# HYUNDAI Technical Service Bulletin

Group	TRANSAXLE
Number	05-40-006
Date	JUNE, 2005
Model	1999- SONATA, 2001- ELANTRA, SANTA FE & XG, 2003- TIBURON, 2005- TUCSON

Subject  
**ATA SOLENOID DIAGNOSTIC CODES P0740, P0741, P0742, P0743, P0746, P0748, P0750, P0755, P0760, P0765, P0770**

***This bulletin supersedes TSB# 03-40-06 to include repair information for DTCs P0746 and P0748 (Variable Force Solenoid).***

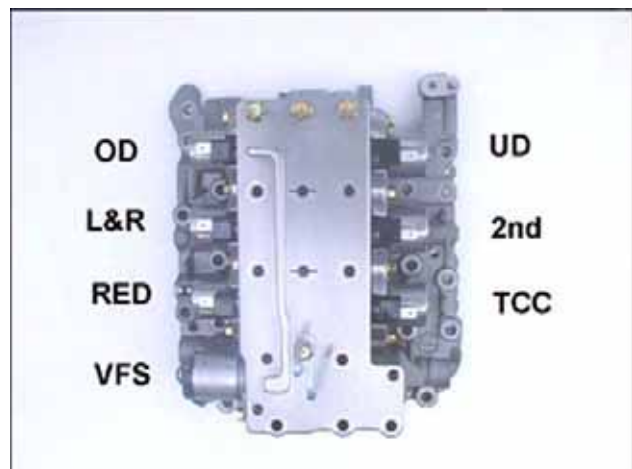
- Remove the battery.
- Drain the radiator. Remove the lower radiator hose from the radiator.
- Drain the ATF.
- Remove the valve body cover from the transaxle.
- Refer to the DTC recorded in Step 1 and replace the related solenoid according to the diagram shown. Tighten the bolts to 4-5 lb.ft (50-70 kg.cm). Go to Step 11.
